CHARTER TOWNSHIP OF GARFIELD PLANNING COMMISSION MEETING

Charter Township of Garfield Planning Department Report No. 2022-97			
Prepared:	October 19, 2022	Pages:	8
Meeting:	October 26, 2022 Planning Commission	Attachments:	<input checked="" type="checkbox"/>
Subject:	7Brew 2537 North US-31 Special Use Permit – Public Hearing		
File No.	SUP 2022-01	Parcel No.	05-021-036-10
Applicant:	2537 N US 31 South LLC – Kevin Myers		
Agent:	BFA, Inc. – John Schebaum		
Owner:	2537 N US 31 South LLC

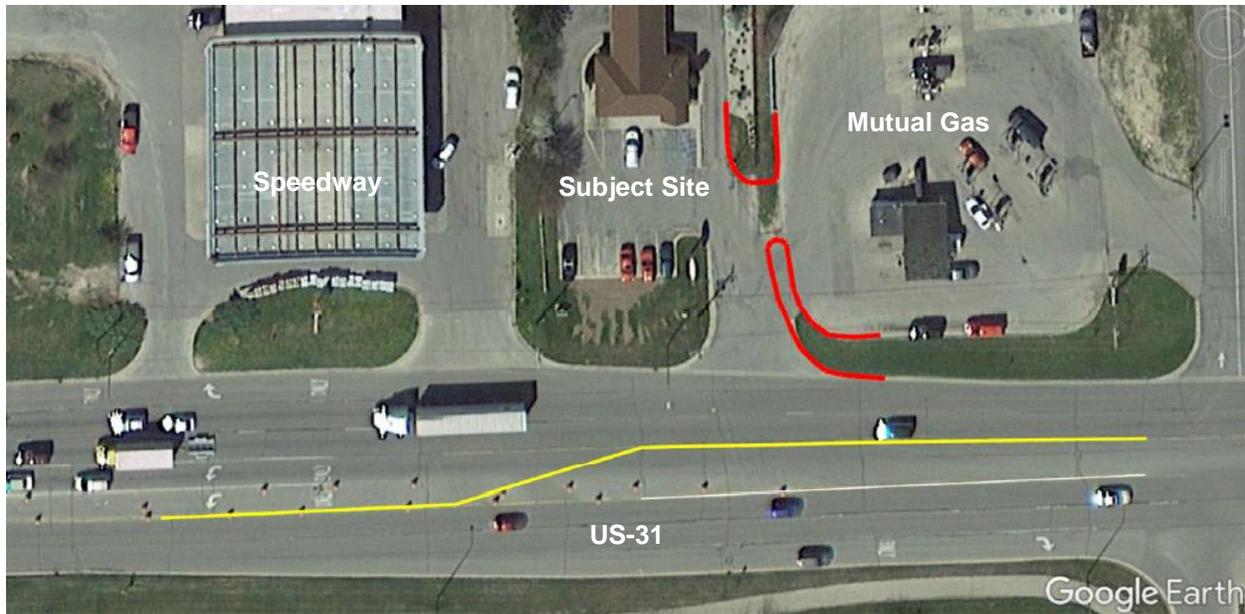
Setbacks:

The front setback is 40 feet in the C-G District; however, drive-throughs are required to have a 60-foot setback from the right-of-way line. Side and rear yards in the C-G District shall be ten percent (10%) of the lot width and depth, respectively, but need not exceed twenty-five (25) feet each, provided that no setback shall be less than ten (10) feet. In this case, the parcel is 100 feet wide, therefore the side and rear yard setbacks shall be 10 feet. The proposed buildings and structures meet the front, side, and rear yard setback requirements.

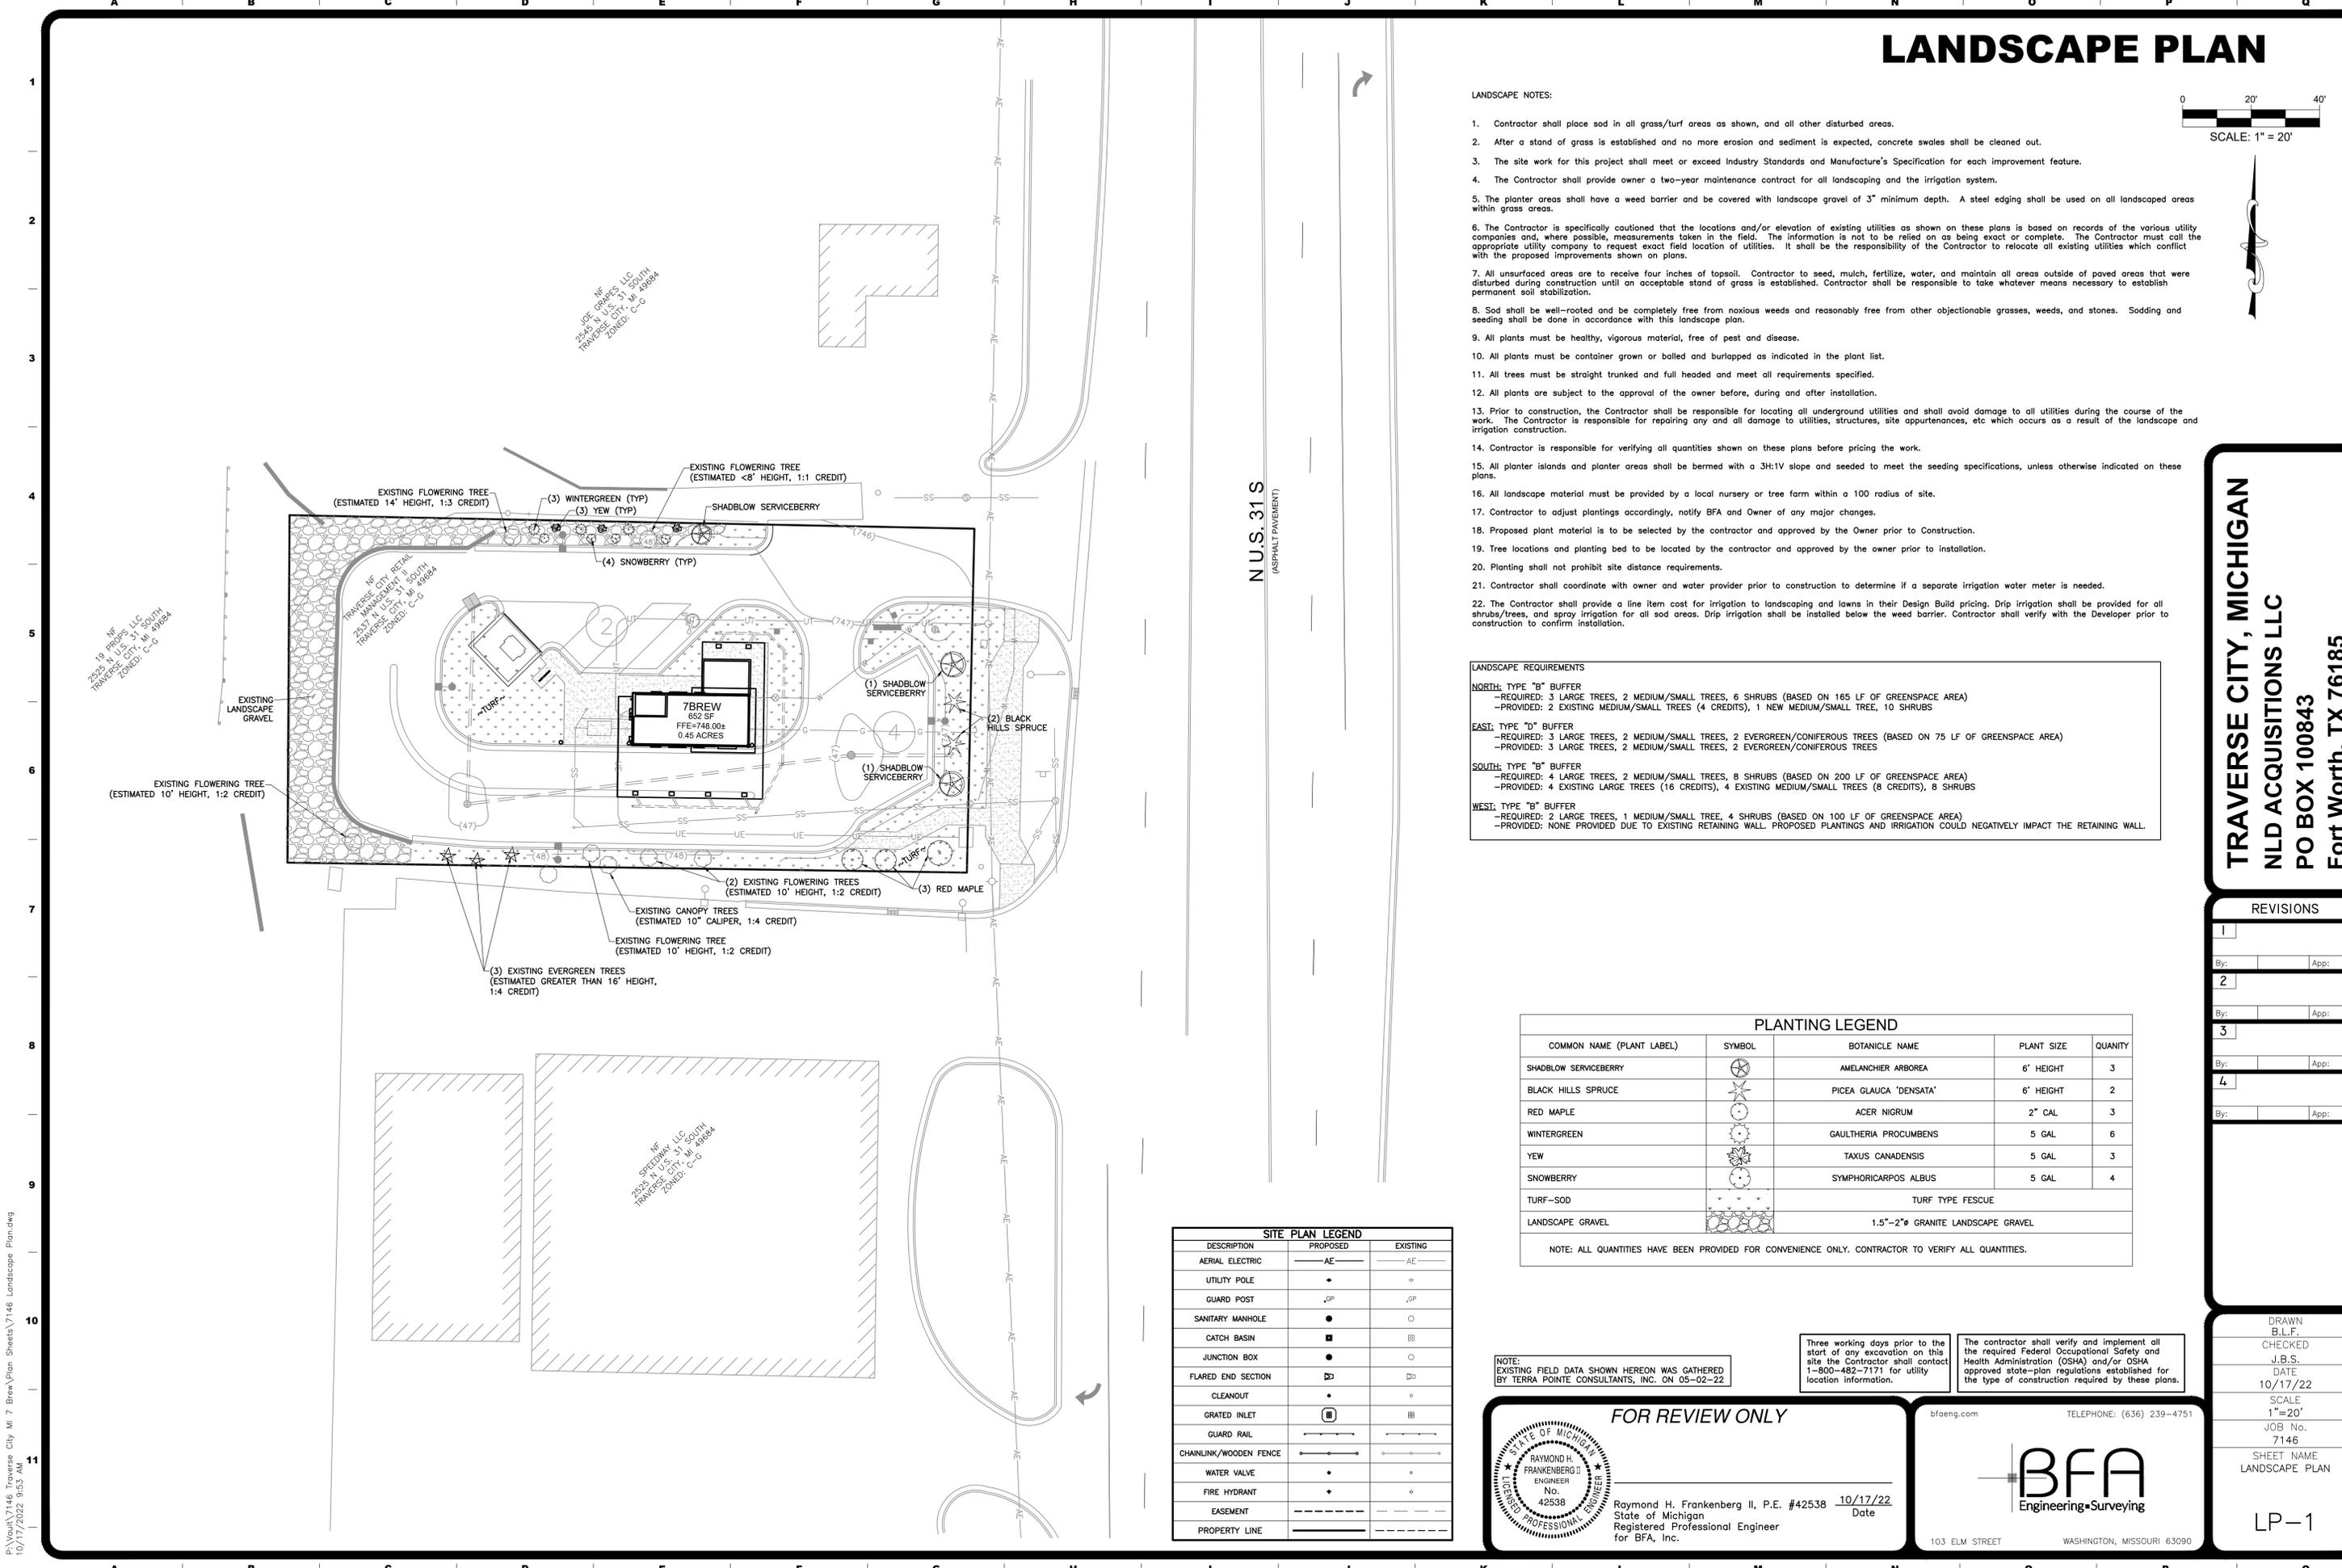
- As proposed, the plantings for the north and south buffers are acceptable due to credit from existing trees. The existing widths of the buffers are substandard with the north at 7 feet and the south at 5 feet, however they are acceptable.
- The existing west buffer consisting of landscape gravel and a retaining wall is acceptable due to the steep slope between the subject site and the existing Best Buy store.

- As proposed, the east buffer meets planting requirements. However, the buffer width is substandard in places.
